**Site Formation and Infrastructure Works
for Public Housing Development near Tan Kwai Tsuen,
Yuen Long – Investigation, Design and Construction**

**FINAL AIR VENTILATION
ASSESSMENT REPORT -
EXPERT EVALUATION**

199086/BIN/104/Issue 3
July 2023

Appendix 1	Cross Sections of Proposed Scheme
Appendix 2	Response to Comments Records

Drawing No. Figure 3.3

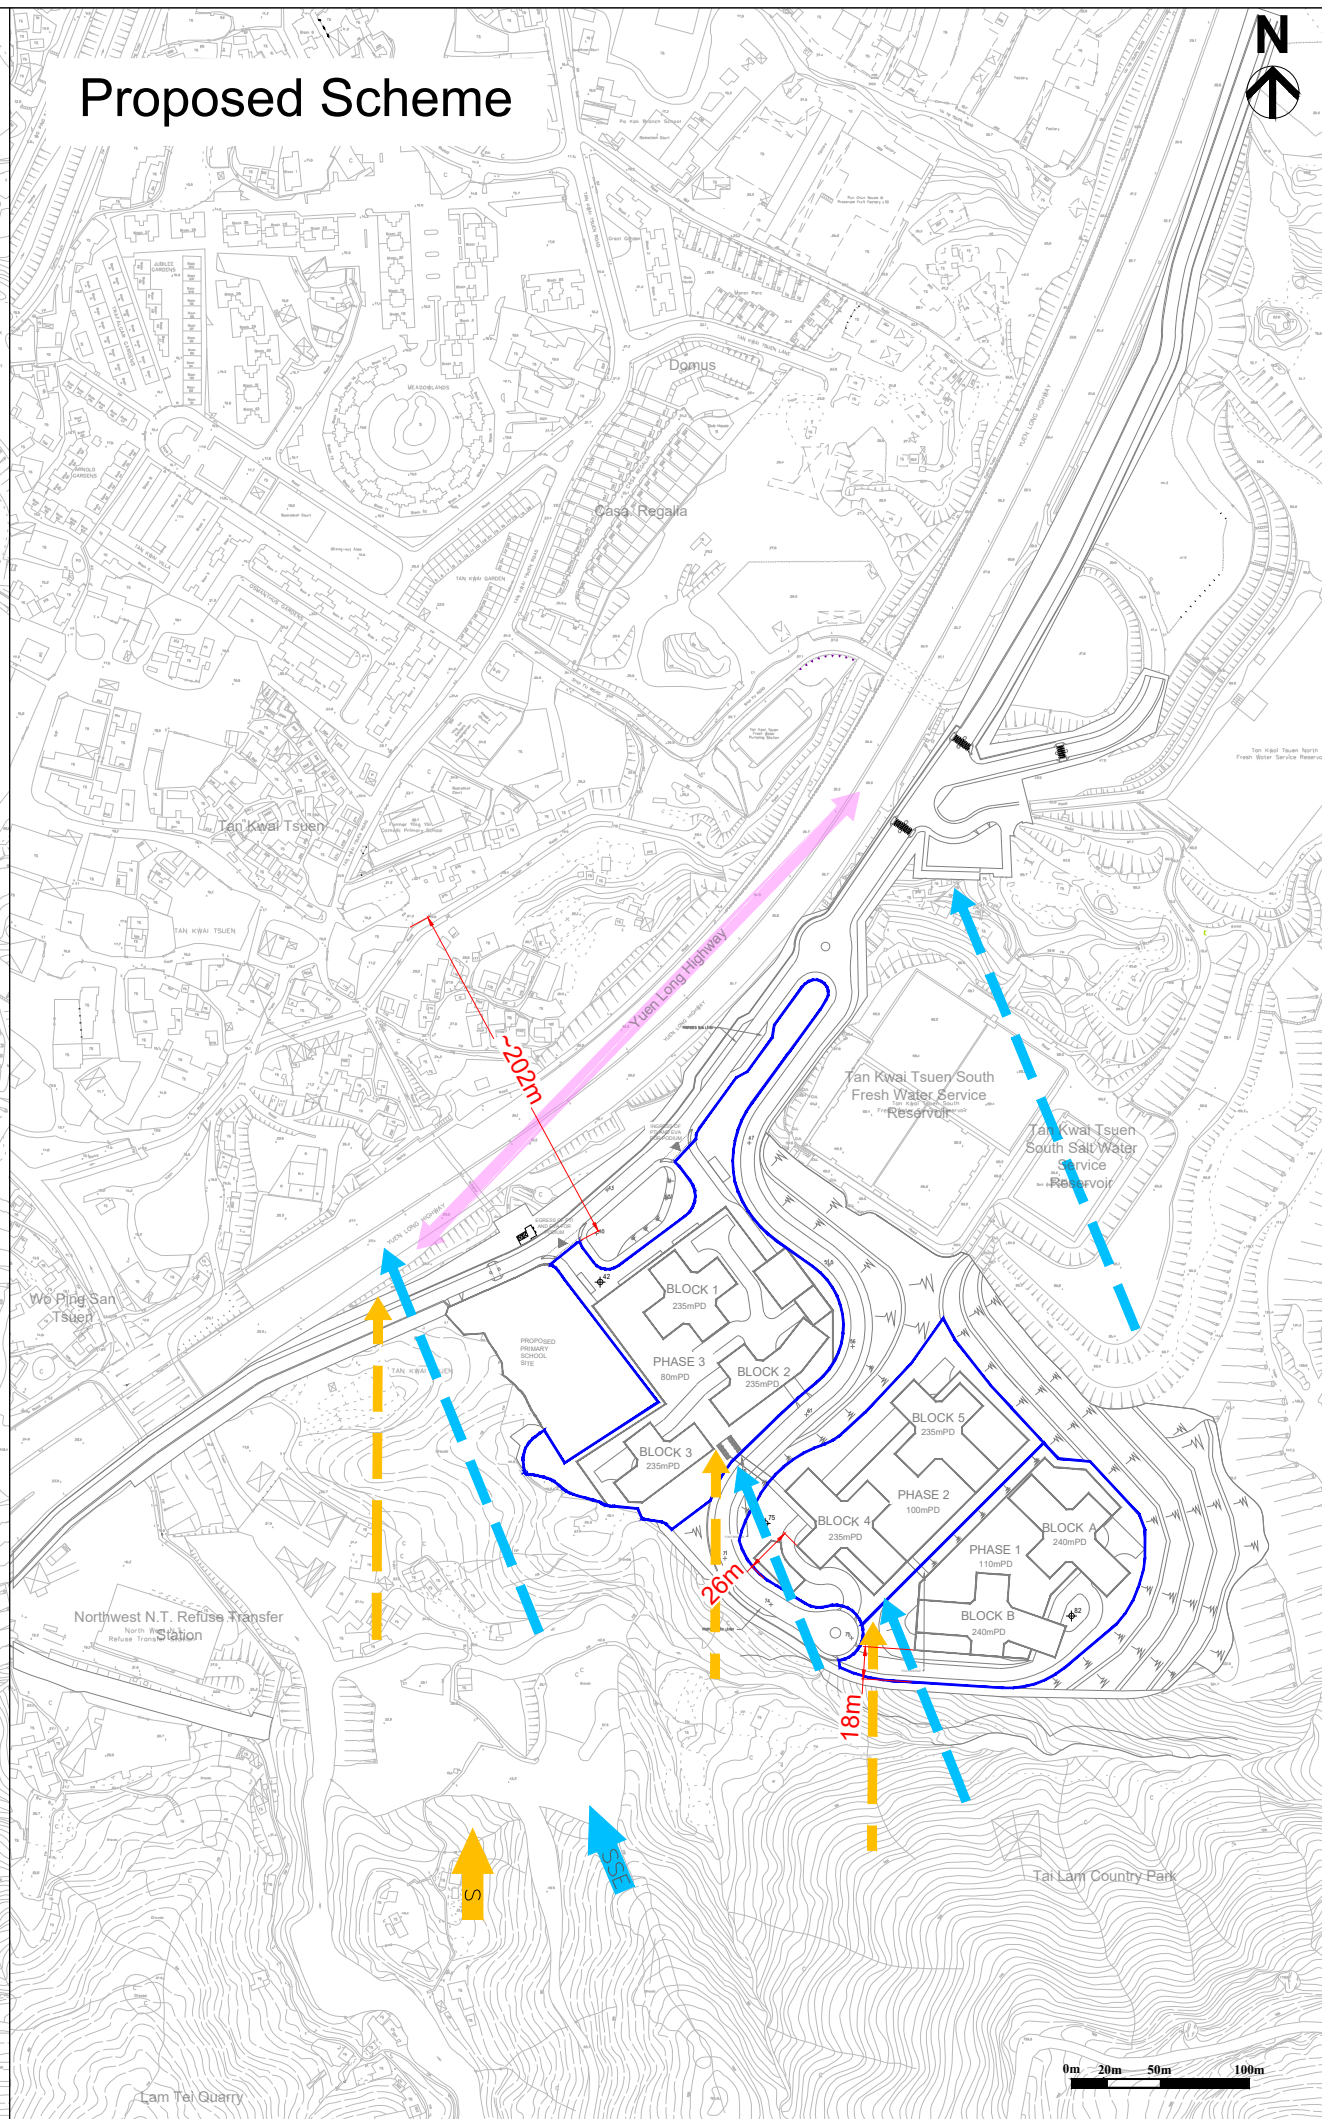
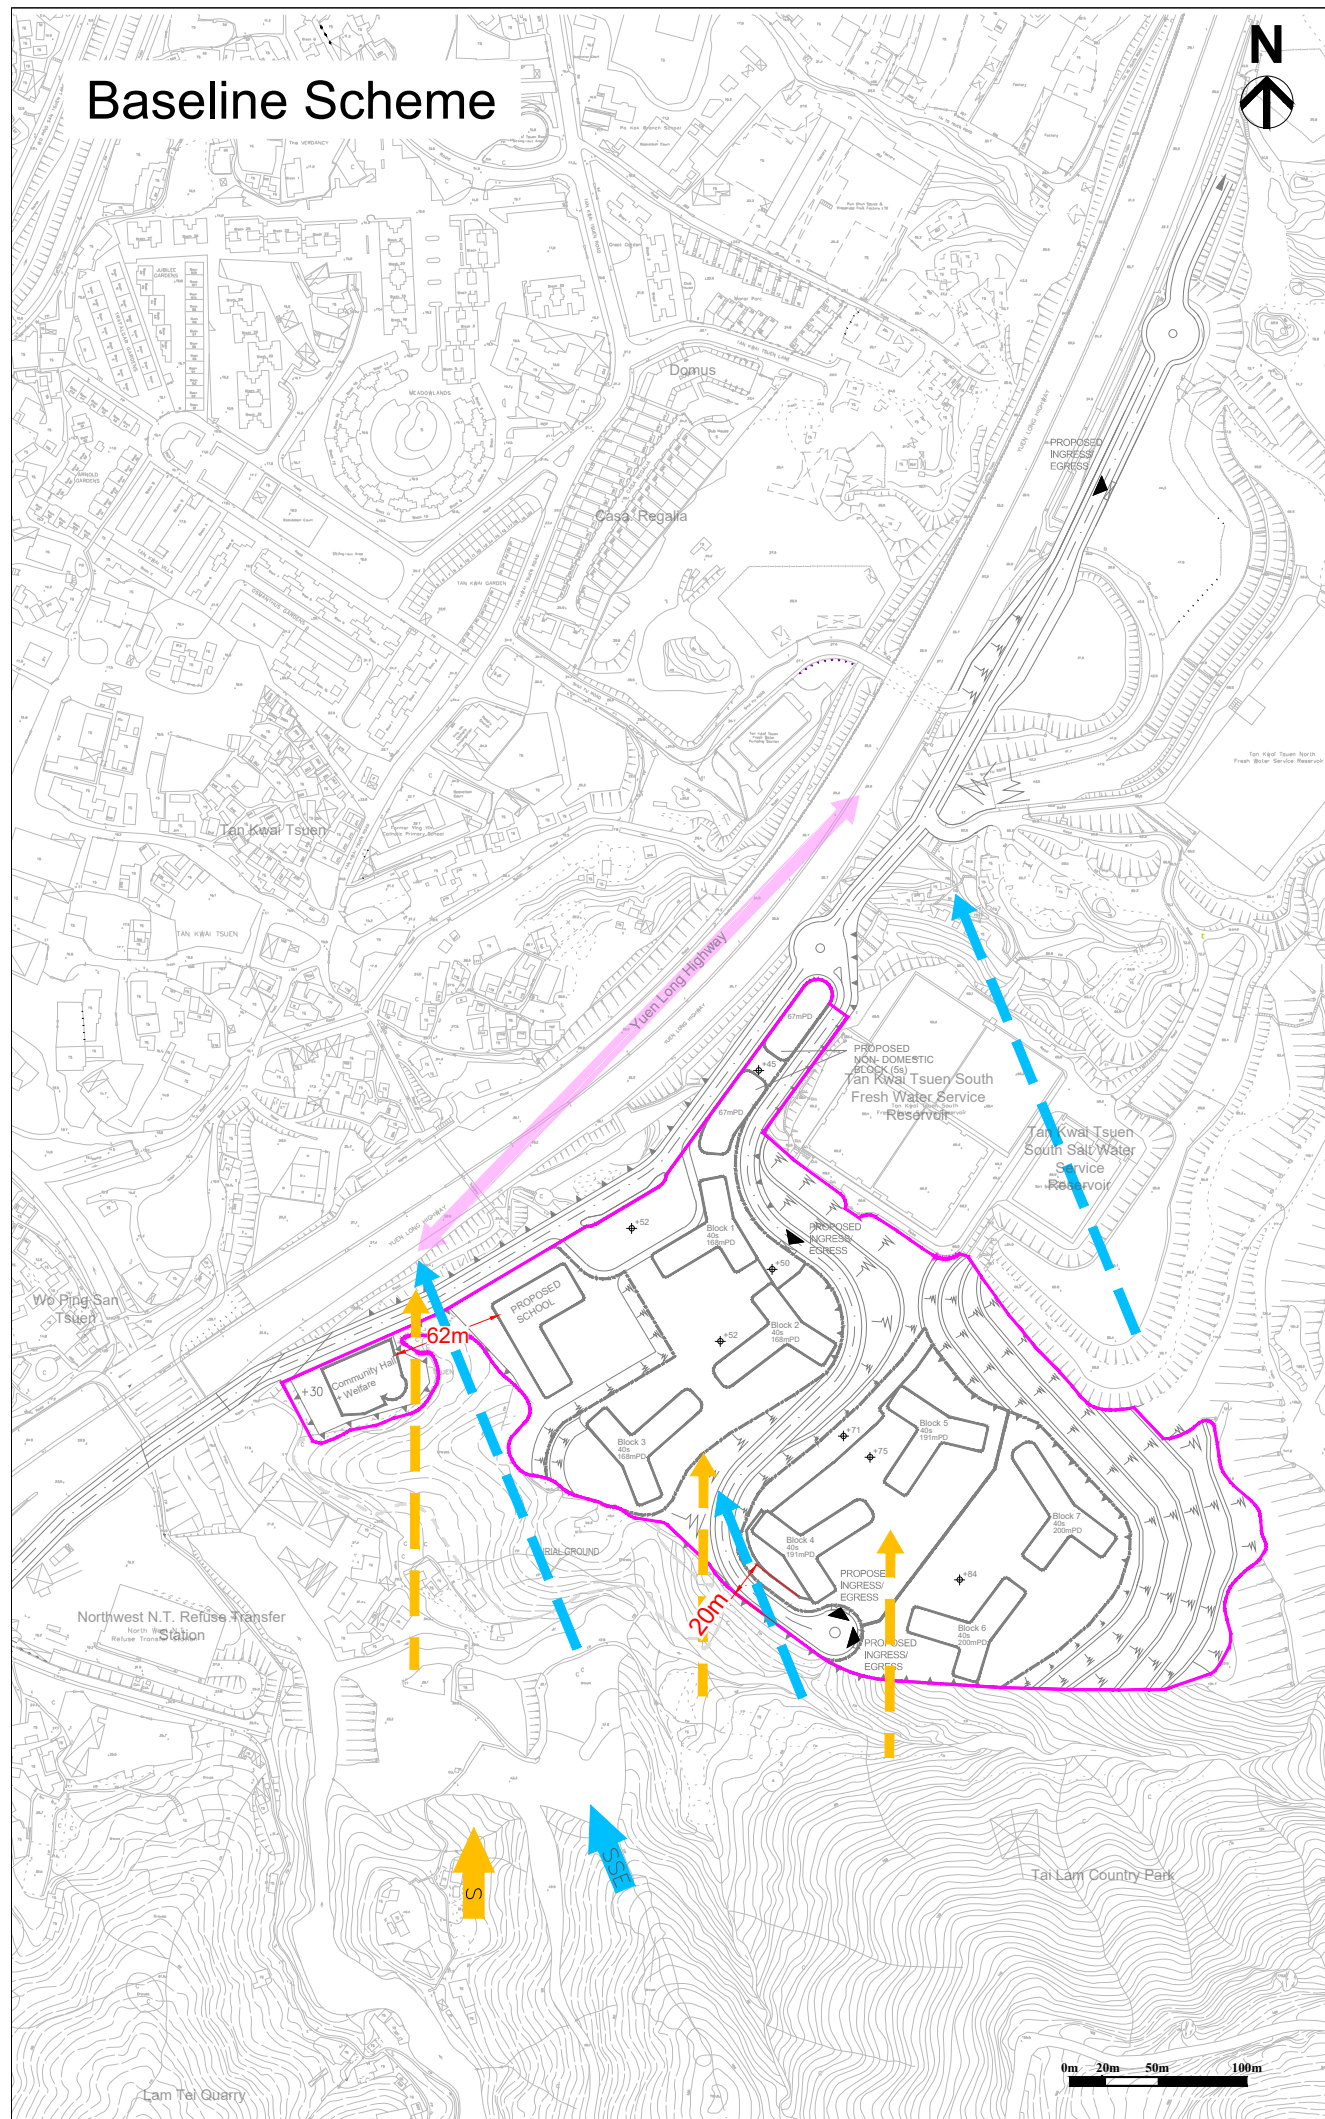
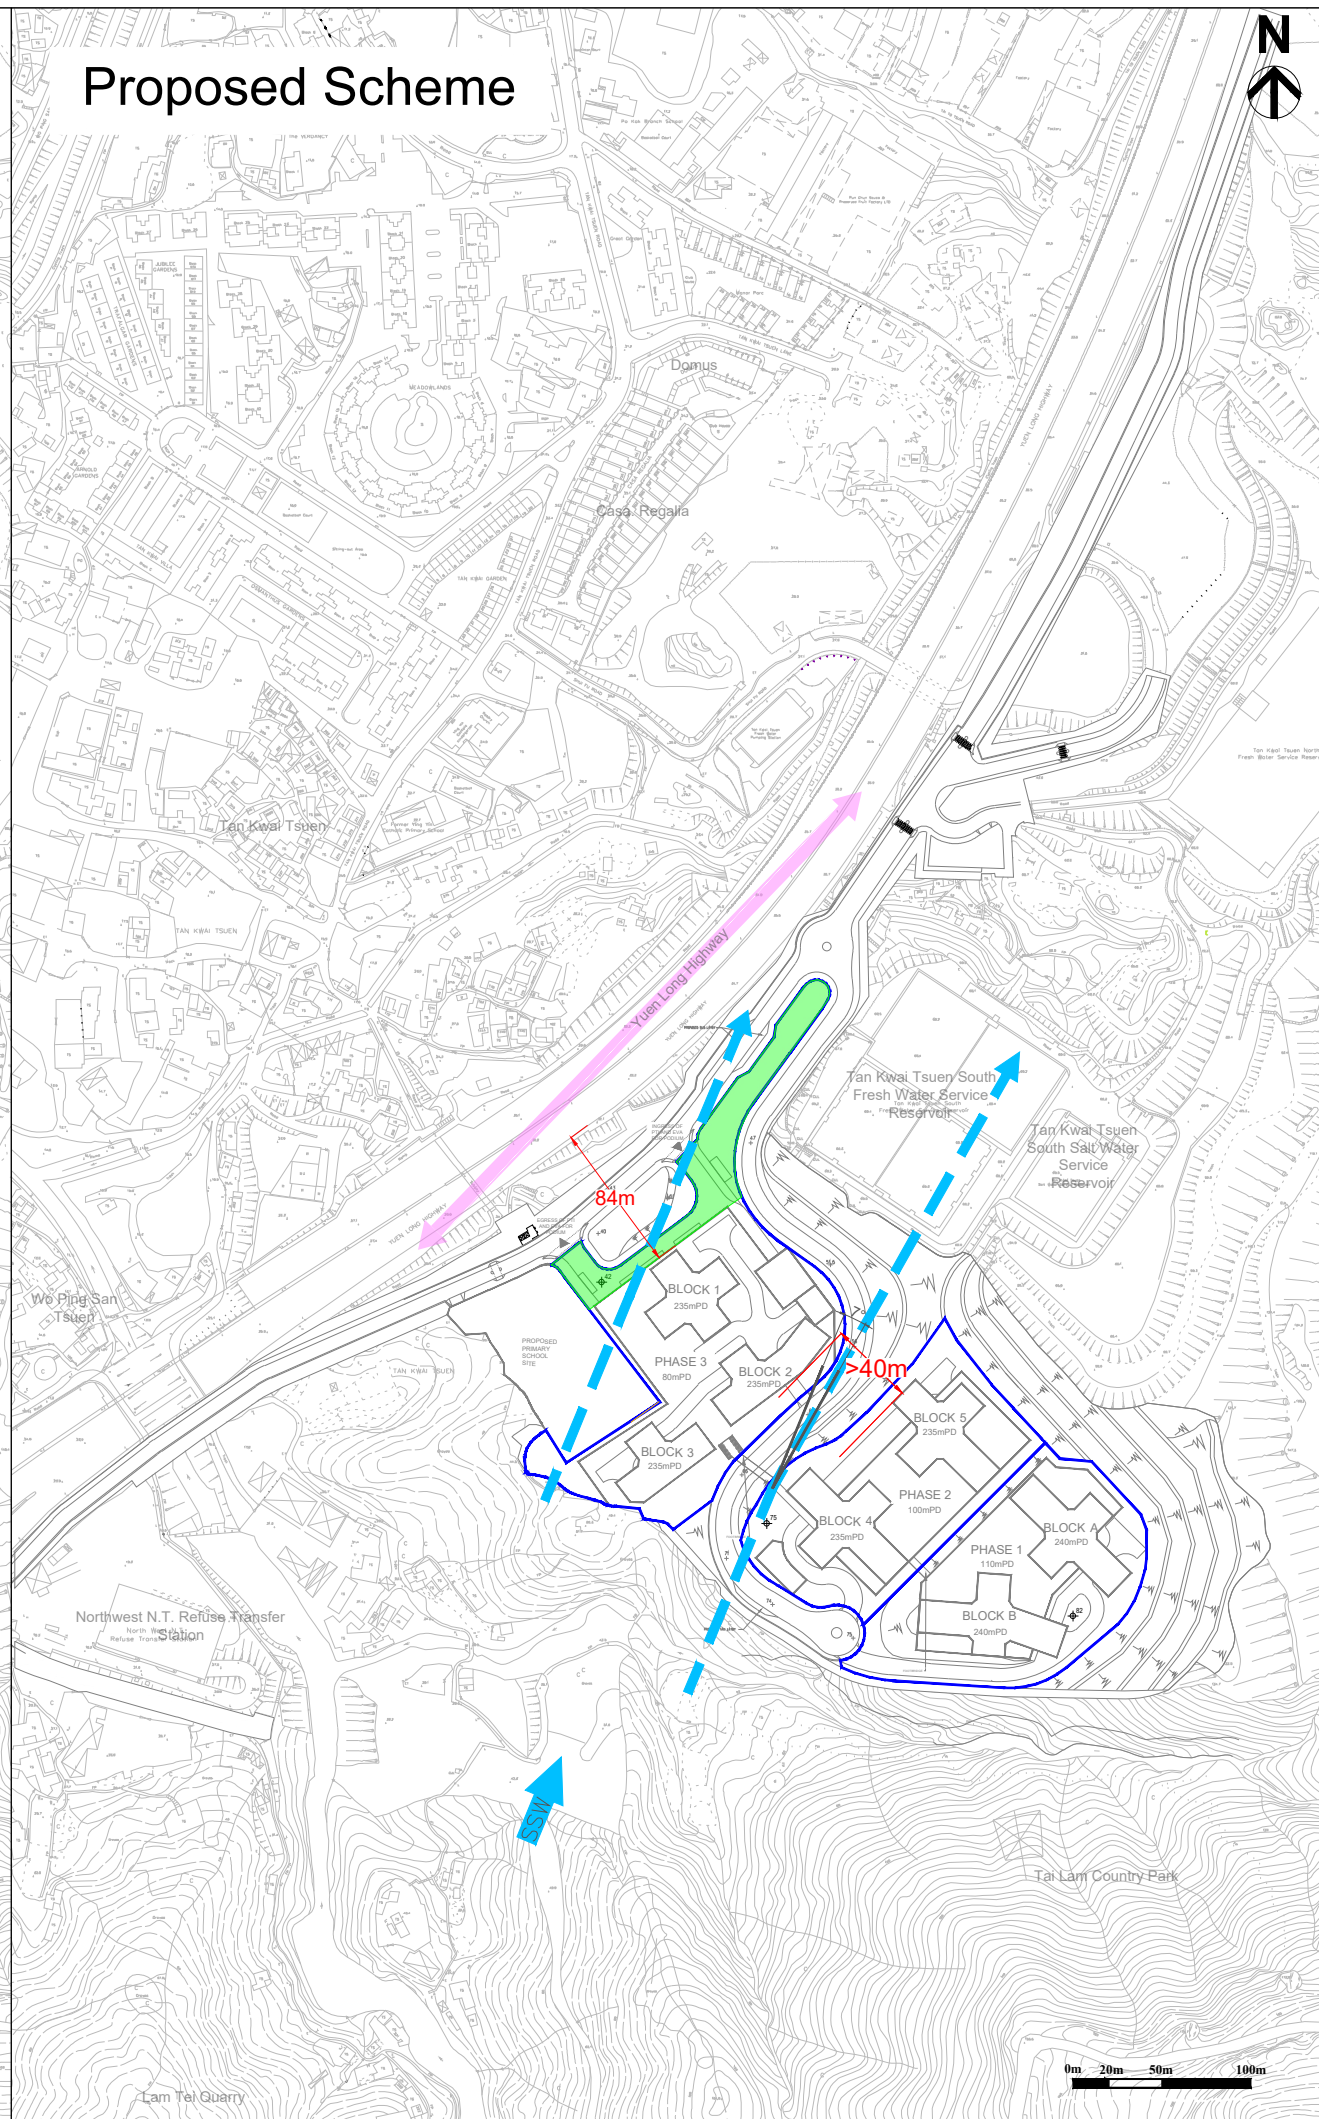
<p>28) Para. 3.3.3 S & SSE Winds – It is unclear on how “the S and SSE winds would replenish along Yuen Long Highway and settle further downstream at Tan Kwai Tsuen and Wo Ping San Tsuen” as stated by the Consultant. Please justify and indicate the distance between the proposed</p>	<p>Noted. The distance between the proposed development and its nearest downstream area (i.e. Tan Kwai Tsuen) has been indicated in Paras. 3.2.9, 3.3.3 and 3.4.3. Figures 3.2 and 3.3 are revised accordingly.</p>
